ADDENDUM #1

**PROJECT: EMS STATION NO. 9
CITY PARISH PROJECT NO. 21-ASC-CP-1495**

**New EMS Station No. 9
8850 Connell's Village Lane
Baton Rouge, LA 70815**

CITY PARISH PROJECT NO: 21-ASC-CP-1495

Professional Seal
 Scale: As Noted
 Sht Description:
 Schedules and Details

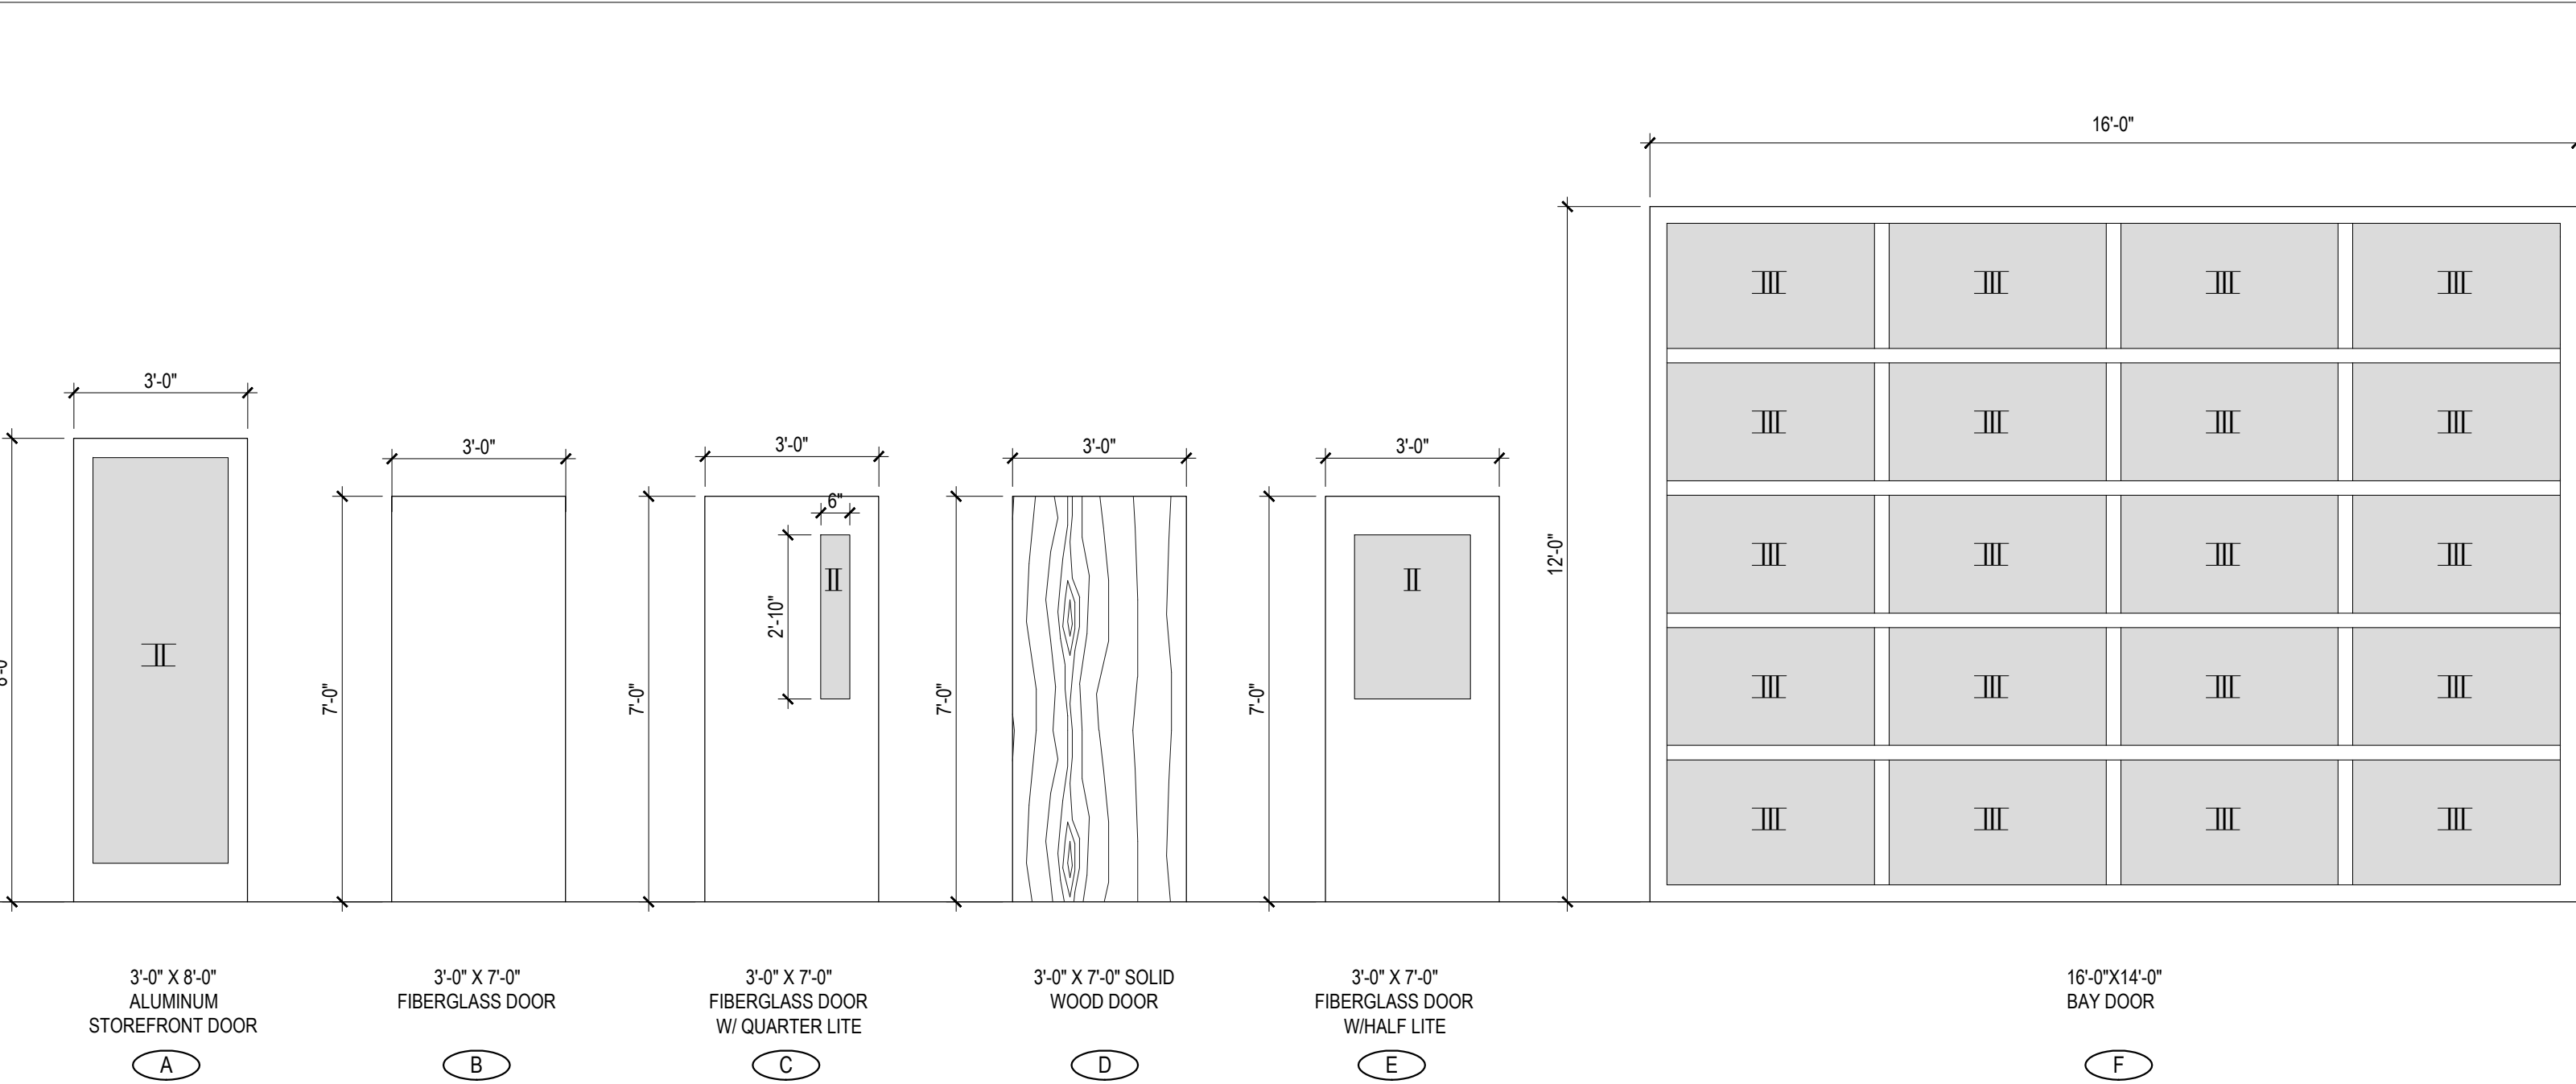
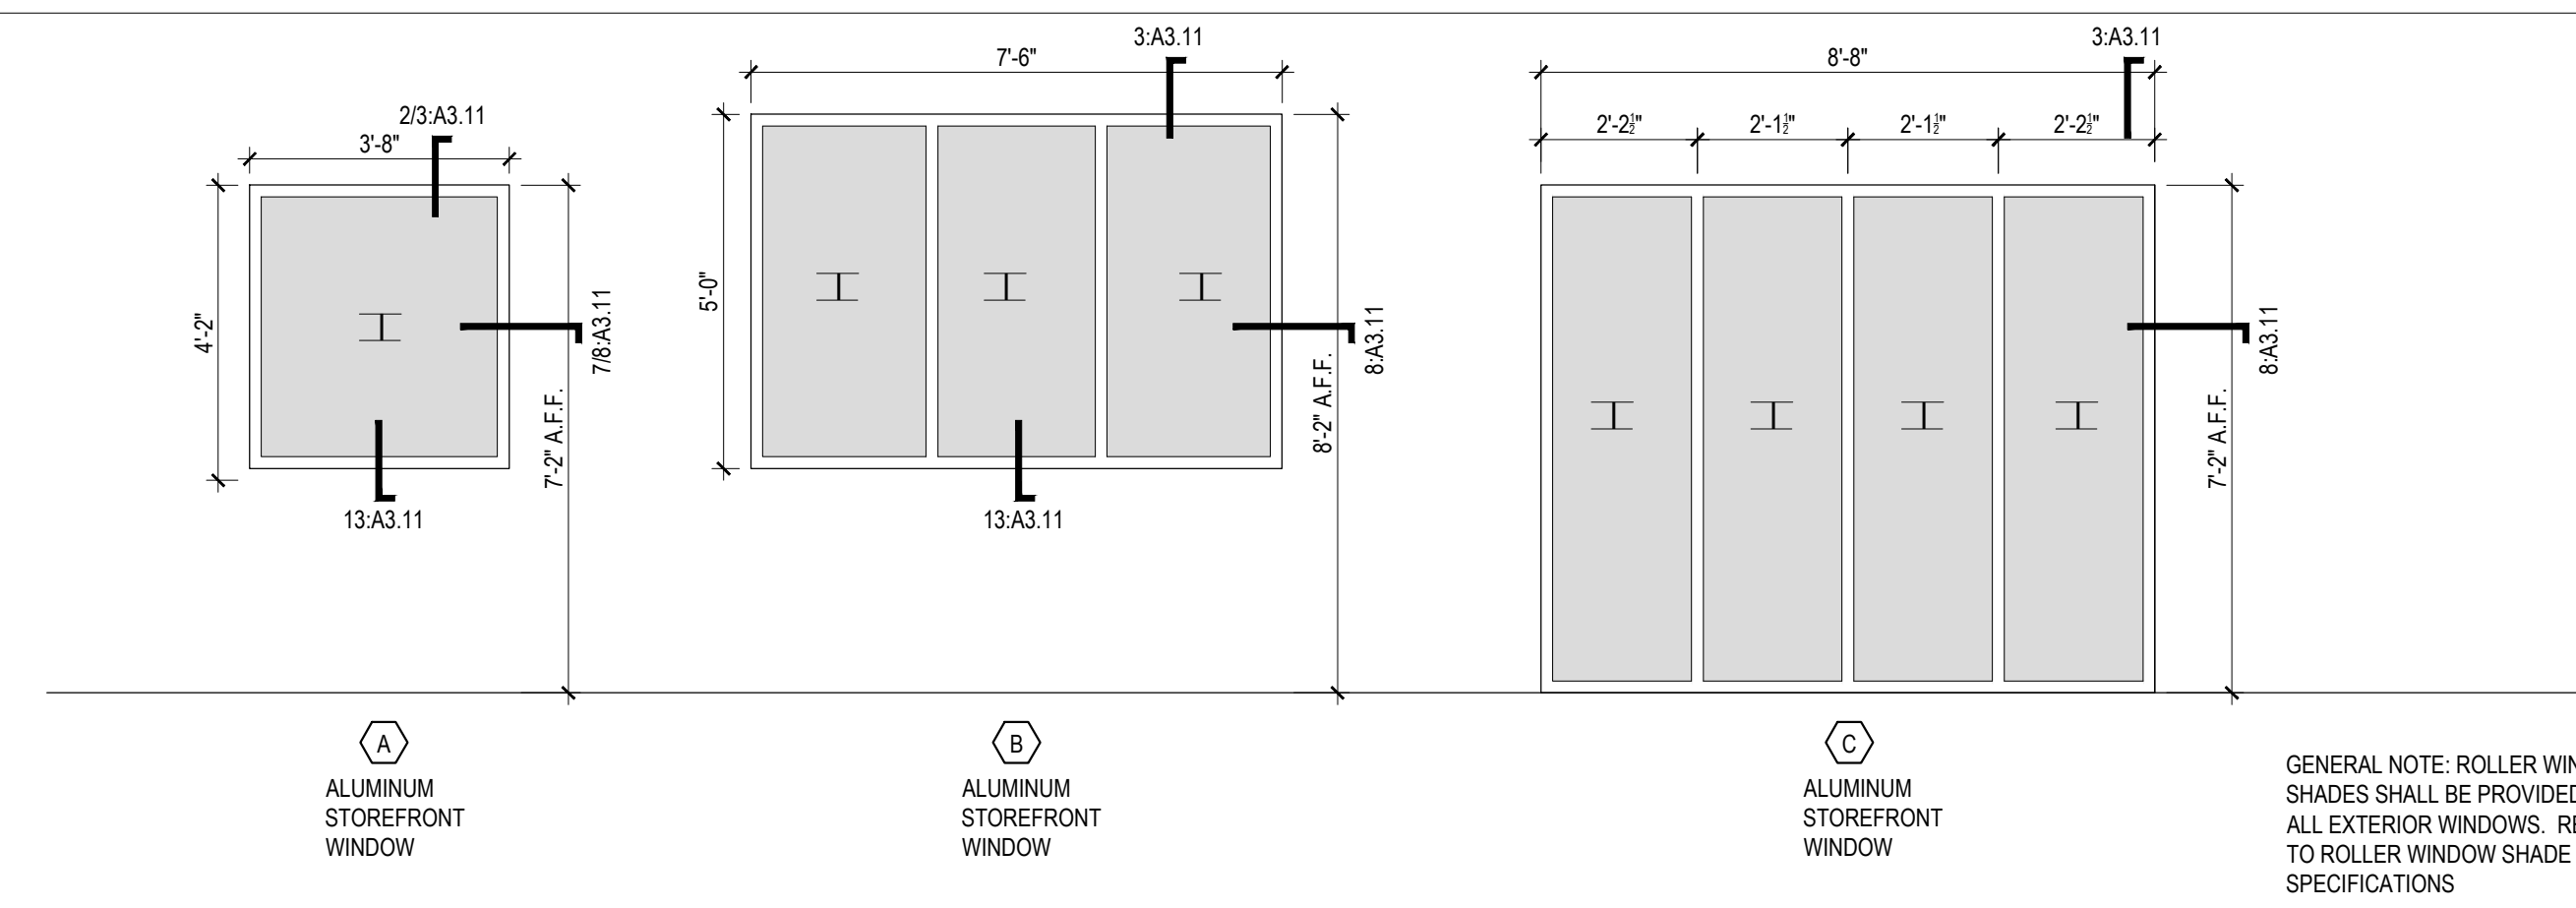
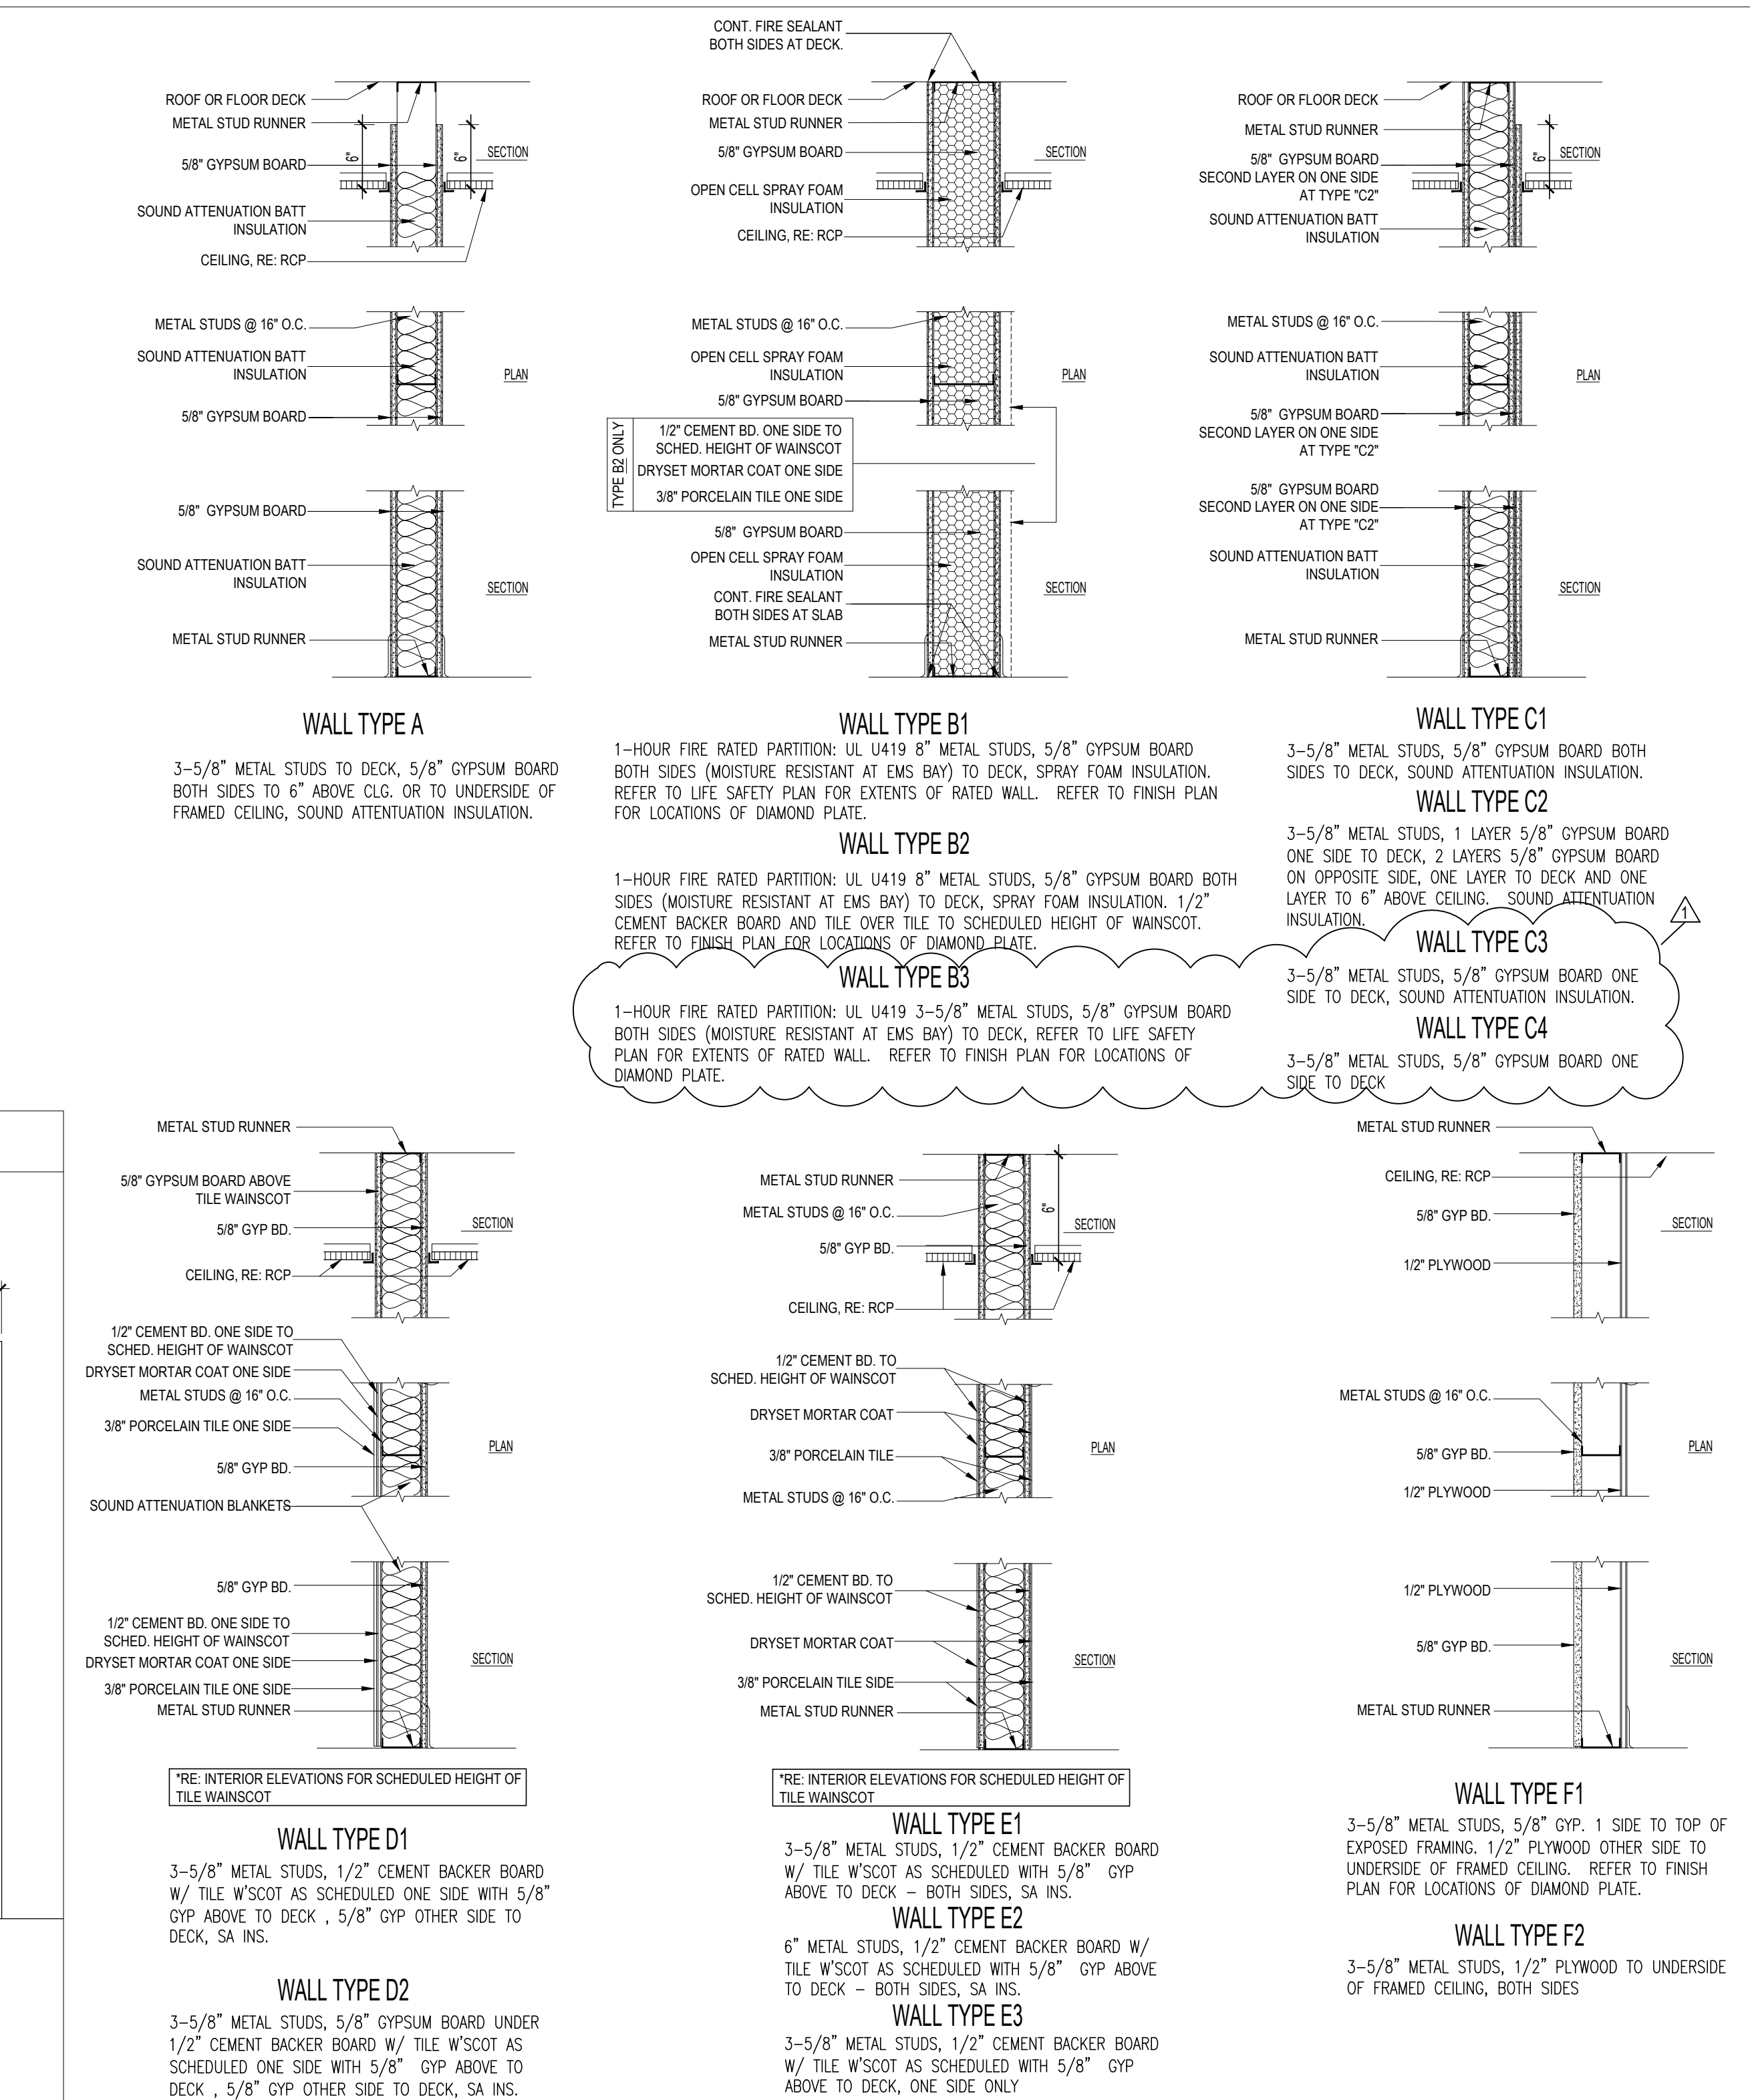
- Sheet A3.01 - Schedules & Details
 - Remove Existing Sheet A3.01 from the bid documents
 - Replace with attached Sheet A3.01, revisions include, but are not limited to, the following:

- Change Door 117 to rated door
 - Added wall partition types
- Sheet M1.01 – Mechanical Floor Plan
 - Remove Existing Sheet A3.01 from the bid documents

1 MECHANICAL FLOOR PLAN
SCALE: 3/16" = 1'-0"

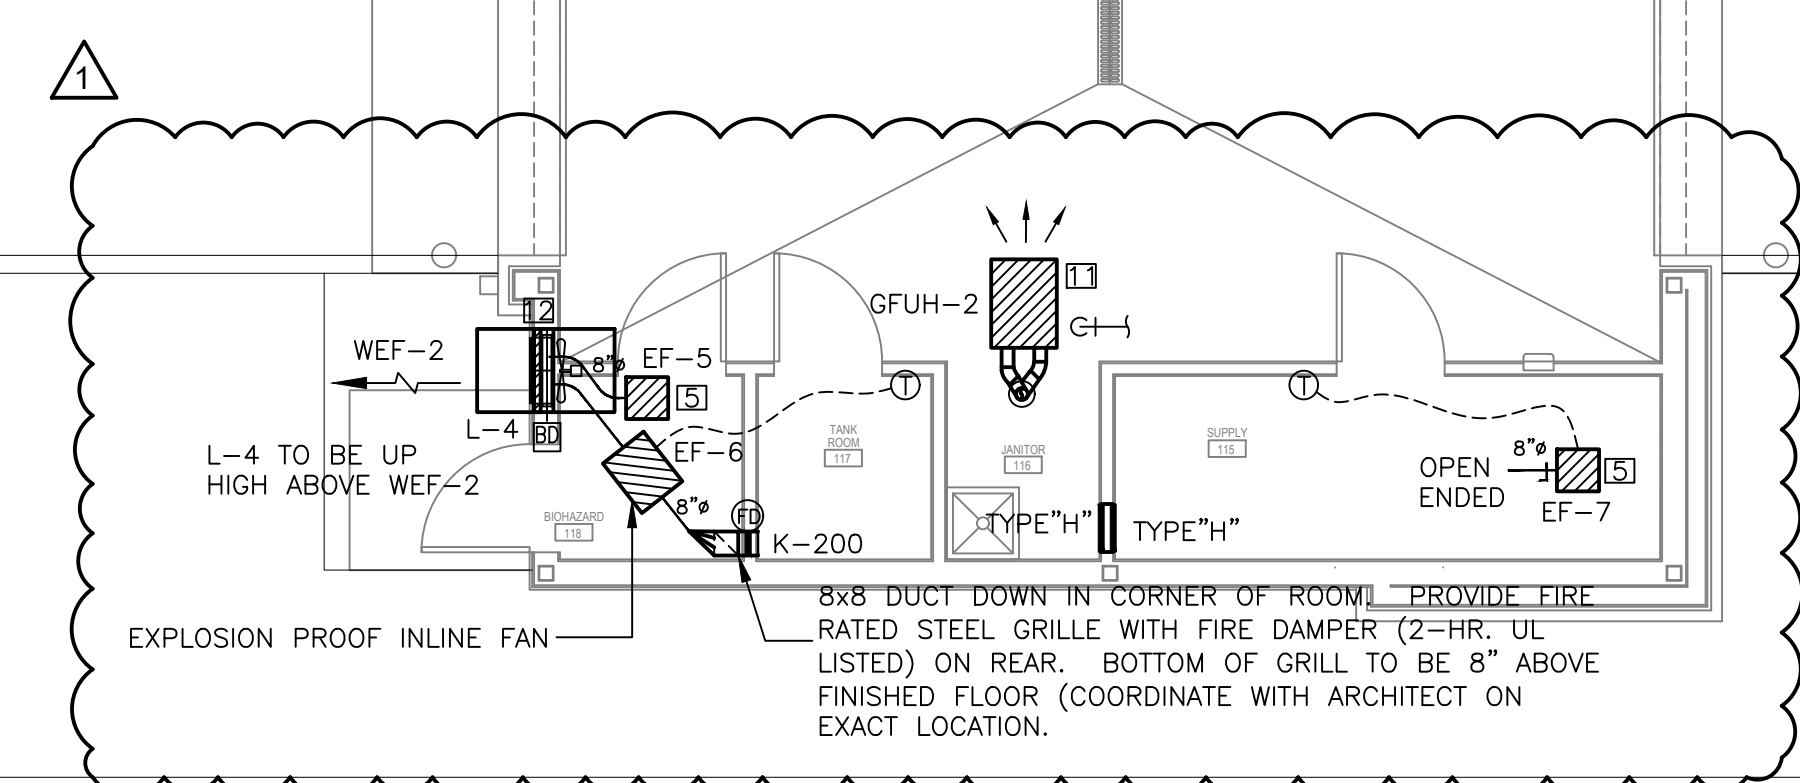
- Replace with attached Sheet A3.01, revisions include, but are not limited to, the following:
 - Revised EF-6 and respective ductwork routing
- Sheet M2.01 – Mechanical Schedules
